Item Name: Replacement Skidtube (Fits LH or RH)

DRAWING NO. D2650	TITLE 206/407 SKIDTUBE ASSEMBLIES	REV. F	DART AEROSPACE LTD ENGINEERING ORDER		D.E.O. NO. D2650-F-1	SHEET NO. SHEET 1 OF 1	SCALE NTS
DRAWN <i>[Signature]</i>	CHECKED A.P.	MFG. APPR. <i>[Signature]</i>	APPROVED <i>[Signature]</i>		DE APPR. <i>[Signature]</i>		
DATE 12.10.12	DATE 12.10.22	DATE 12.10.22	DATE 12.10.22		DATE 12.10.22

CHANGE C'BORED WELDED CROSSBOLT SPACERS TO SWAGED SPACERS

DETAIL G

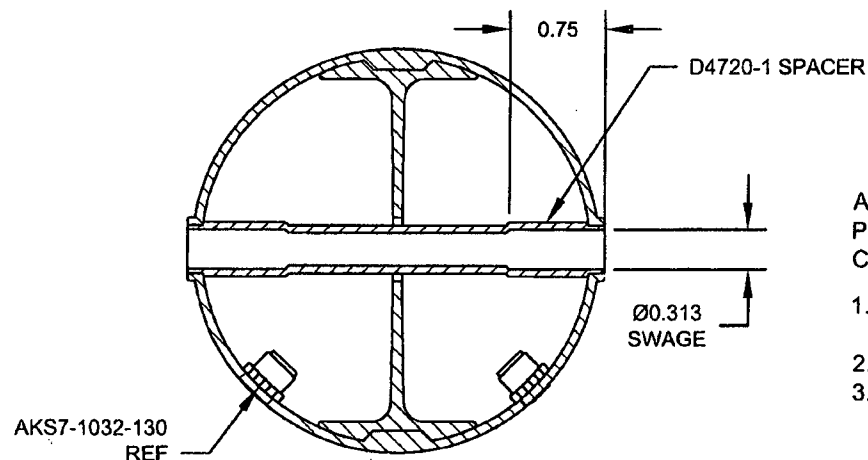
ADD DETAIL G BELOW, WHICH IS THE SAME SECTION VIEW AS DETAIL D OF DWG.

C'BORED HOLES ARE **NOW SWAGED** PER DETAIL G BELOW. FOR THE Ø0.375 HOLE THAT IS NOT C'BORED, WELD PER DETAIL D OF DWG (SEE AMENDED DETAIL B FOR REFERENCE).

D2649 SPACER,
WELD PER DETAIL D OF DWG
BUT DO NOT C'BORE

AFTER DRILLING AND BENDING ASSEMBLY
PERFORM THE FOLLOWING FOR Ø0.375 HOLES THAT ARE
CURRENTLY C'BORED:

1. INSERT D4720-1 SPACER, 16 PL (-1) OR 17 PL (-3)
OR 19 PL (-5) OR 23 PL (-7)
2. SWAGE TO Ø0.313 X 0.75 DP PER QSI 002
3. TRIM / GRIND FLUSH PER QSI 002
